**HOWELL TOWNSHIP PLANNING COMMISSION
REGULAR MEETING**

DITCH WITCH EXPANSION

RE: Ditch Witch Expansion
Parcel ID #4706-28-200-040
Preliminary Site Plan Review, Second Review

RMB COMMERCIAL, LLC
 4590 W. GRAND RIVER AVENUE
 HOWELL, MI. 48843
SITE PLAN

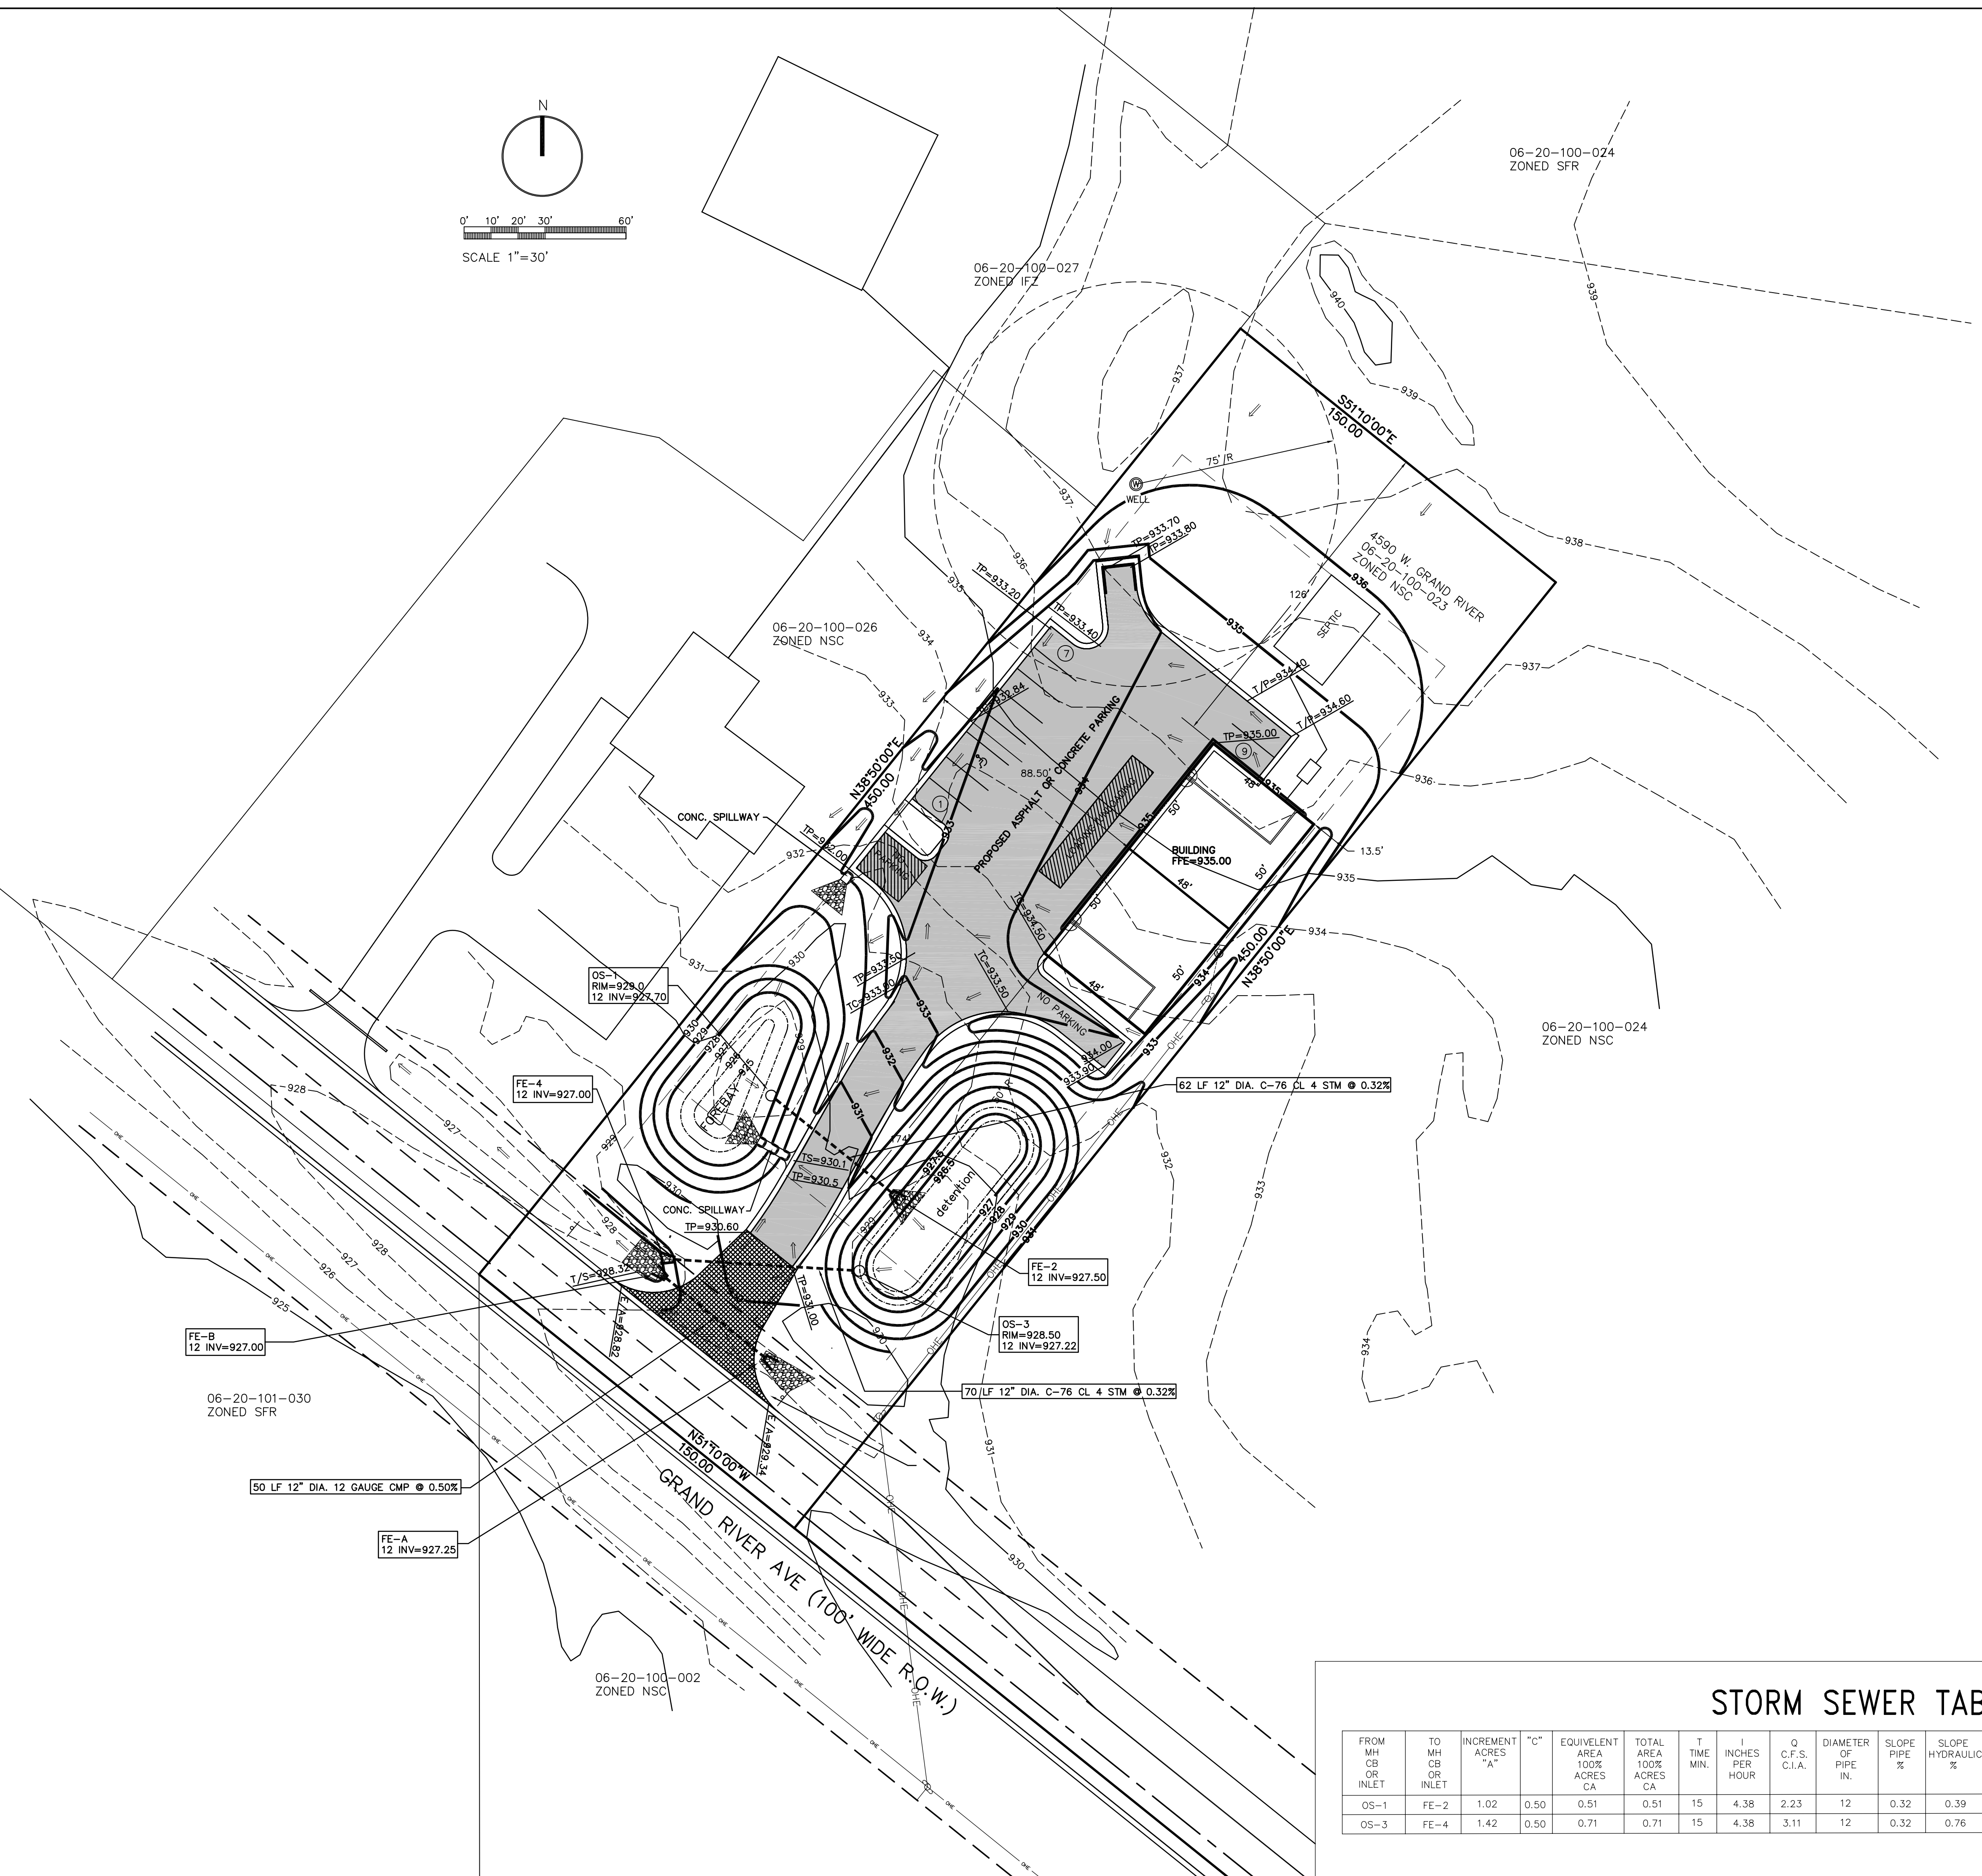
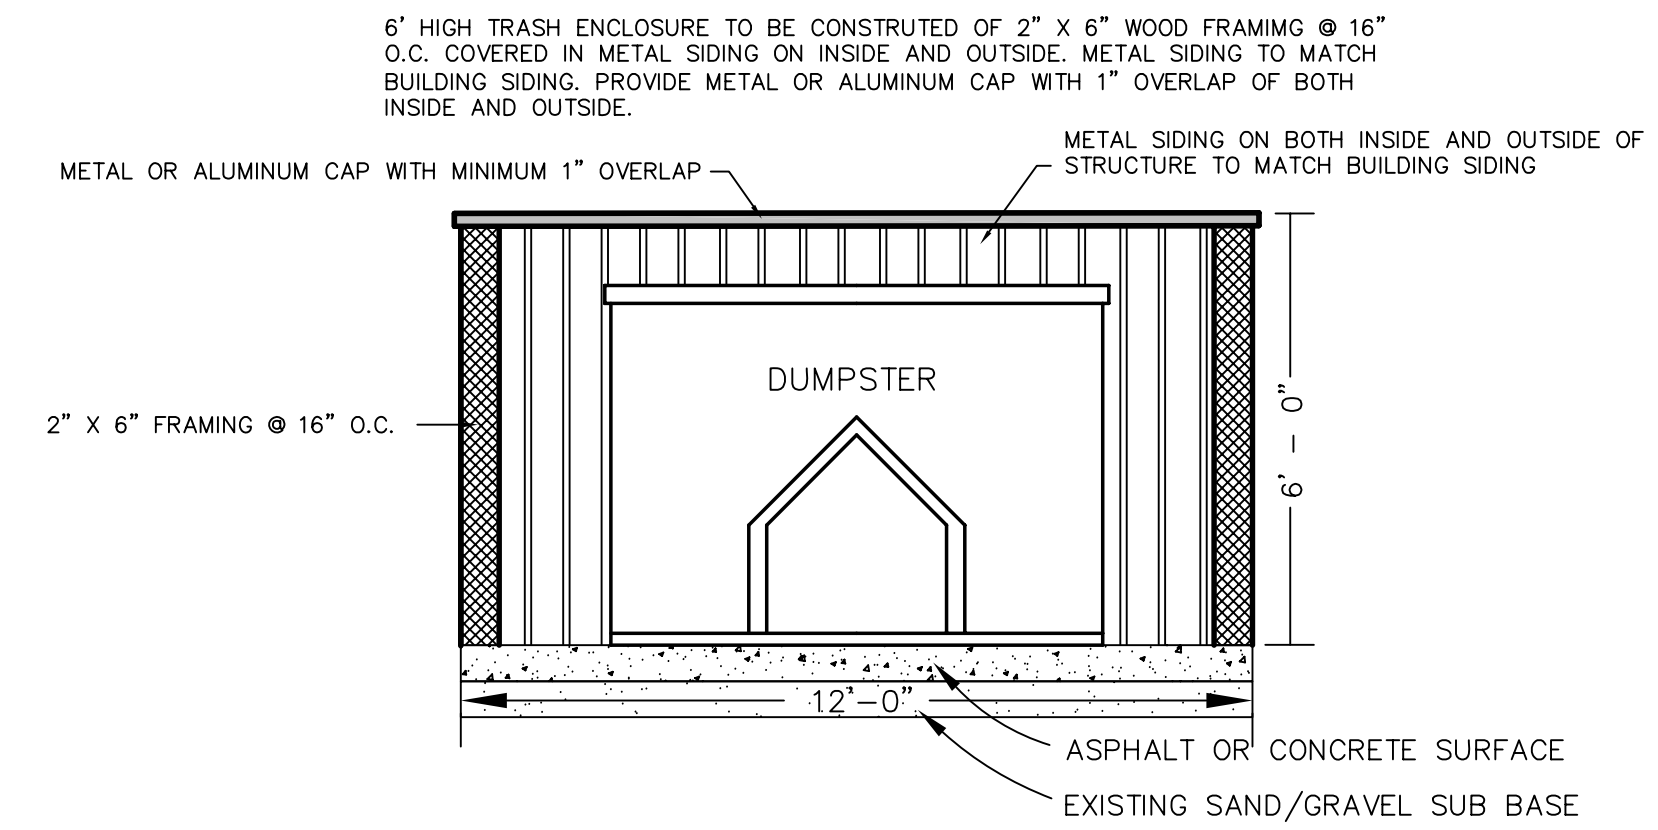
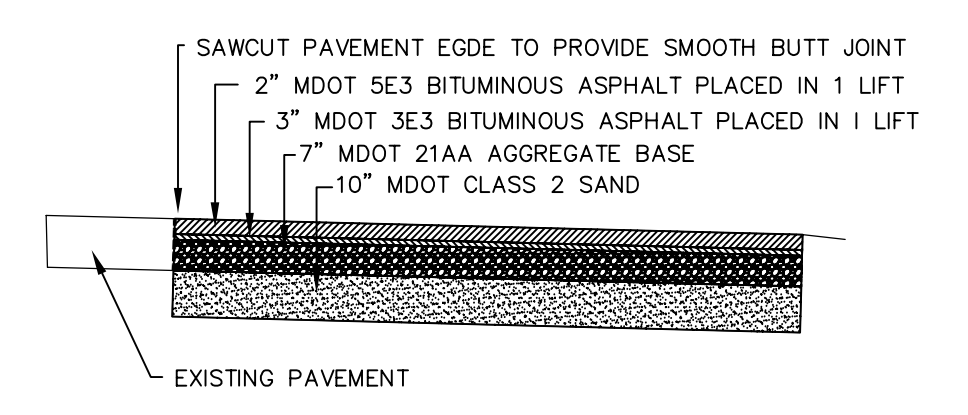
The applicant needs to update the front setback to be fifty (50) feet as the site is along West Grand River, and the west side yard setback to say eighty-eight point five (88.5) feet in the zoning data listed on sheet 3. The building setbacks do comply with the requirement.

- 1) *The front yard setback shall be updated to fifty (50) feet.*
- 2) *The side yard setback shall be updated to eighty-eight point five (88.5) feet in the zoning data listed on sheet 3.*

There is a note on Sheet 3 stating that three (3) wall pack light fixtures are being proposed on the west side of the building. They will be mounted at twelve (12) feet tall and have shields. The light shall not exceed no more than one (1) foot candle at the property line. Lighting shall be directed away and shielded from neighboring properties. A lighting plan was provided on Sheet 9 shows that lighting will trespass onto neighboring properties.

- #4 A pavement cross section detail has been added to sheet 3 of the plans that calls for a heavier pavement section within the Livingston County Road right of way.

- #5 Notes and details have been added to sheet 3 of the plans to show the approach adjustments and deceleration paint striping adjustments requested by the Livingston County Road Commission.

- #7 The required front yard setback has been increased to 50 feet along Grand River Avenue. The detention pond has been redesigned to fall outside of a 20 foot front yard setback as required in section 26.05 of the zoning ordinance.
- #8 Traffic on the site will generally be employee cars and service vans for HVAC services. A truck circulation plan has been added (sheet 8 of the plans) to demonstrate the possible fire truck and occasional garbage truck movements on the site.
- #9 The loading space has been moved to the side of the building and dimensions added.
- #10 End caps have been added to the end of the parking areas.
- #11 The landscape plan has been revised to add three trees and seven shrubs to provide the required foundation landscaping.

RMB COMMERCIAL, LLC
 4590 W. GRAND RIVER AVENUE
 HOWELL, MI. 48843
LANDSCAPE PLAN

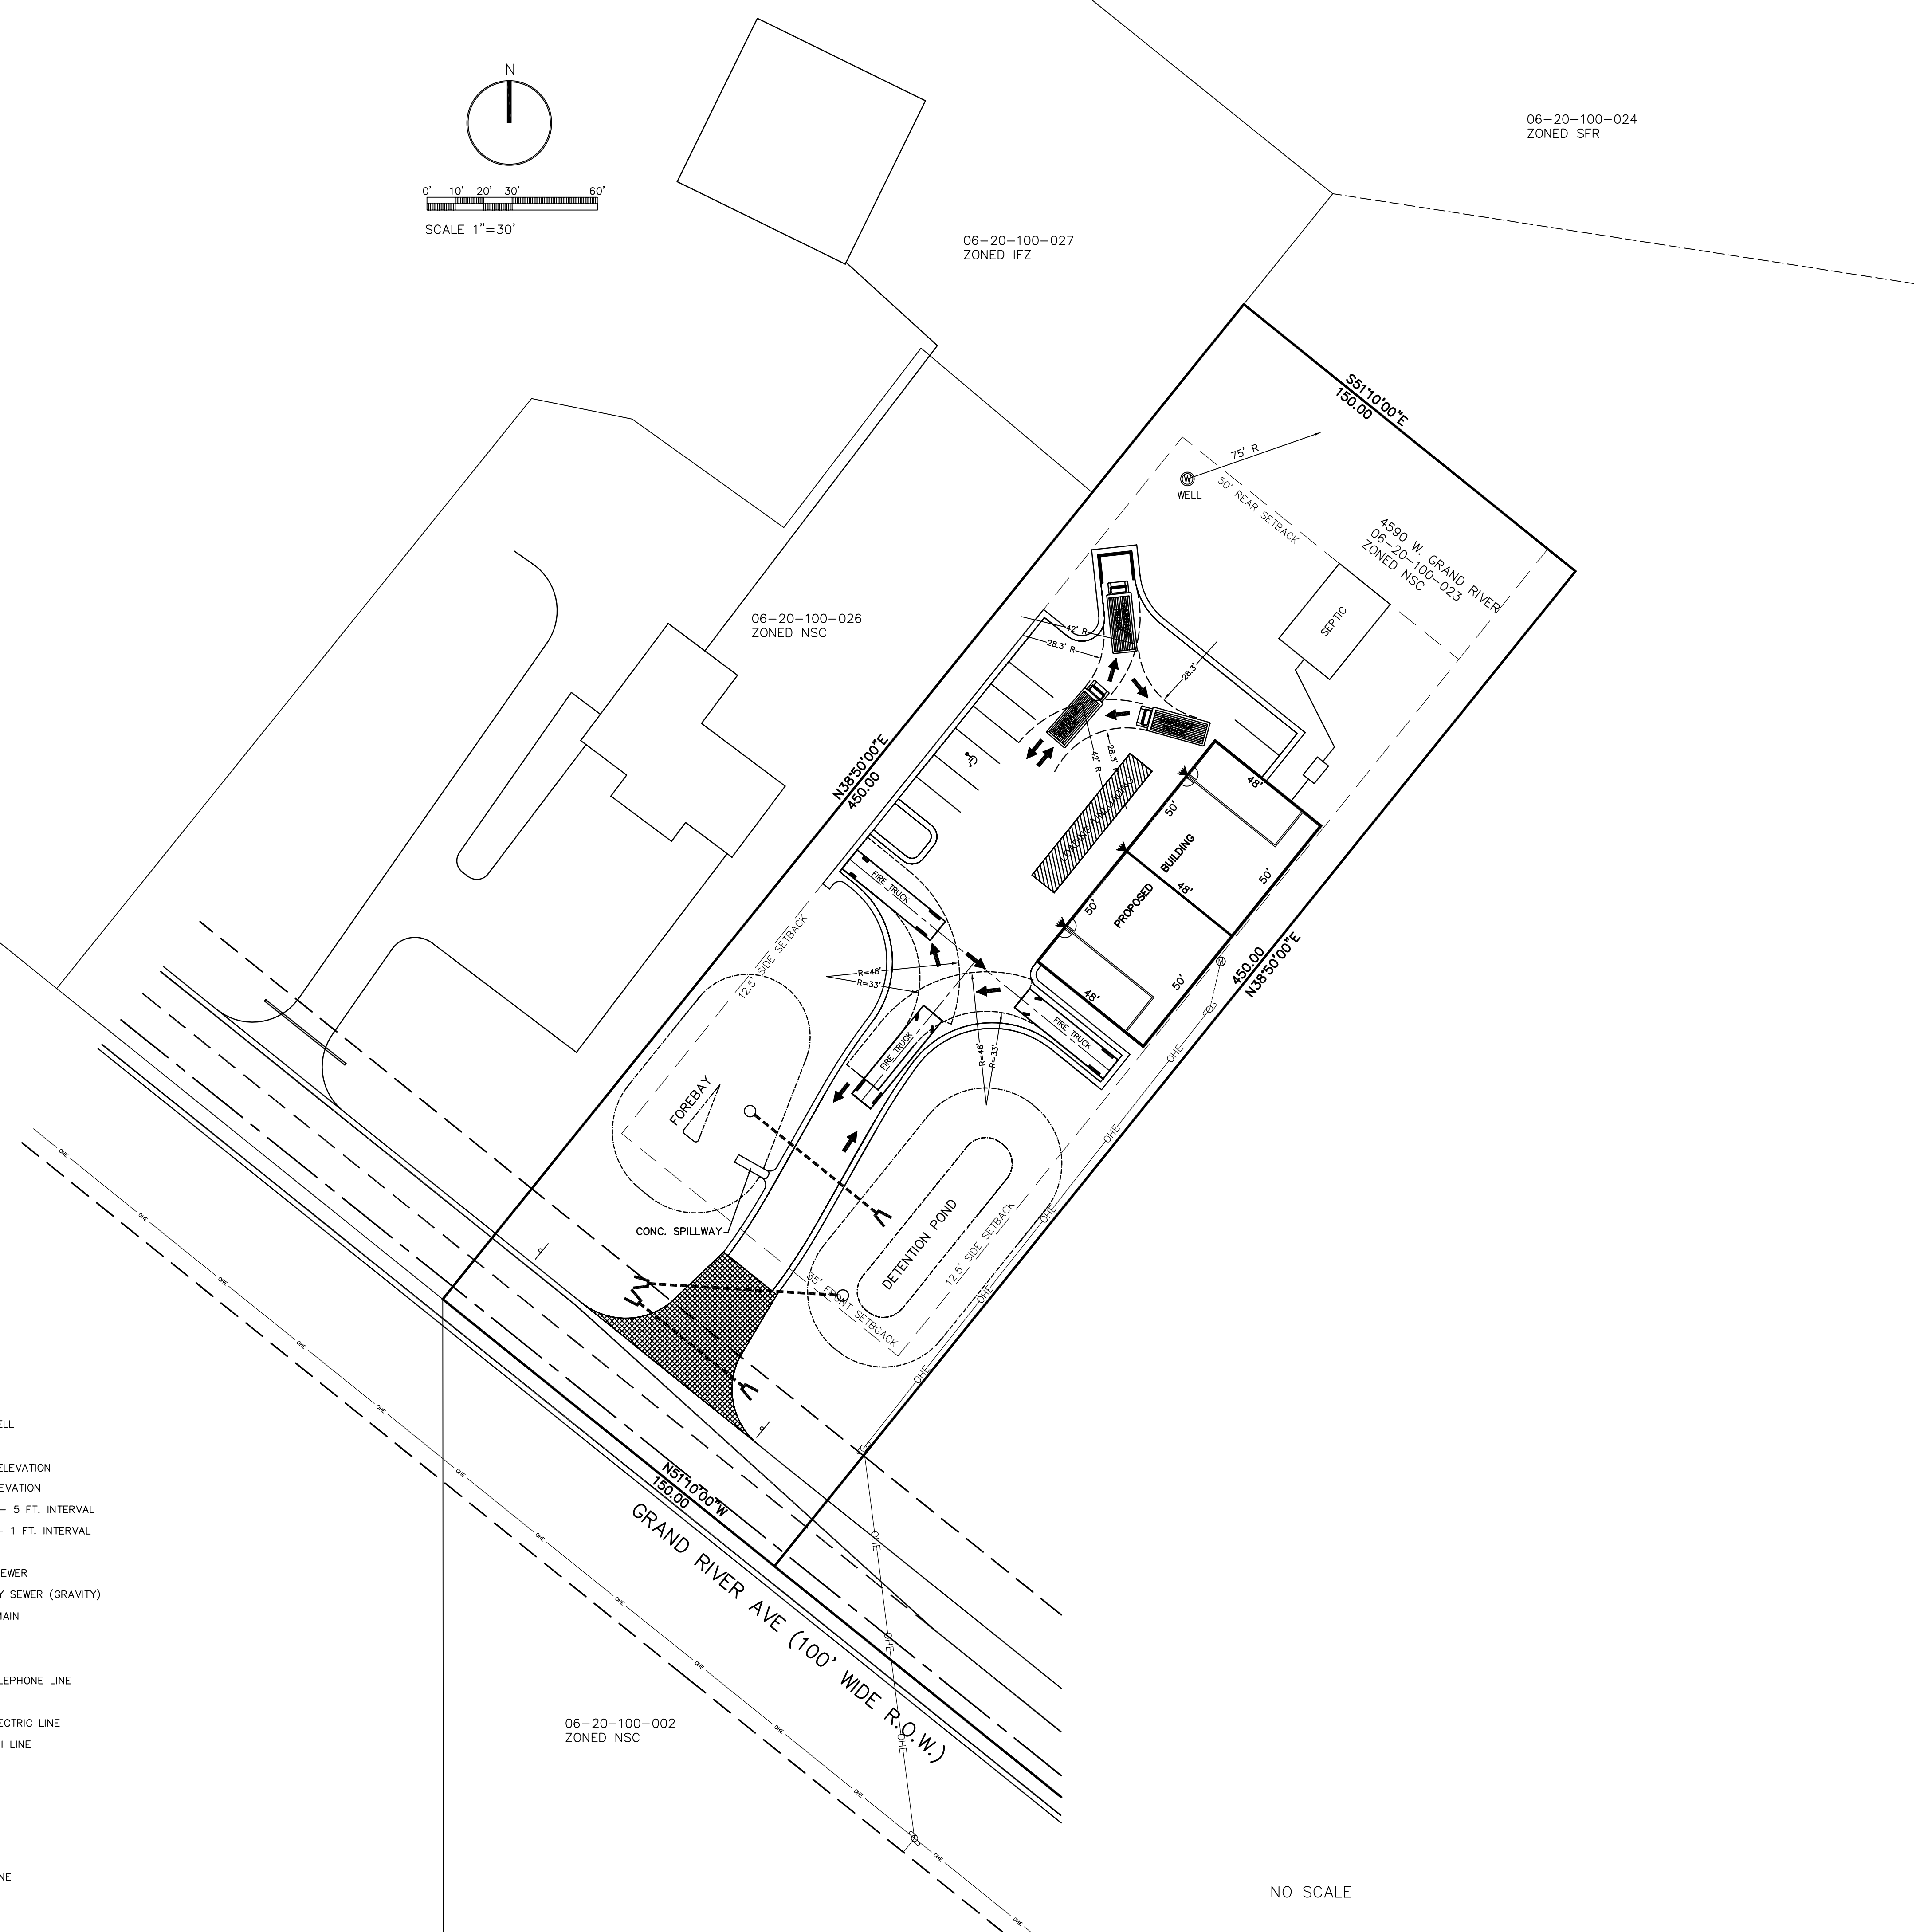
A landscaping plan has been provided on Sheet 7. Landscaping requirements are noted in **Table 3** are representative of the entire site.
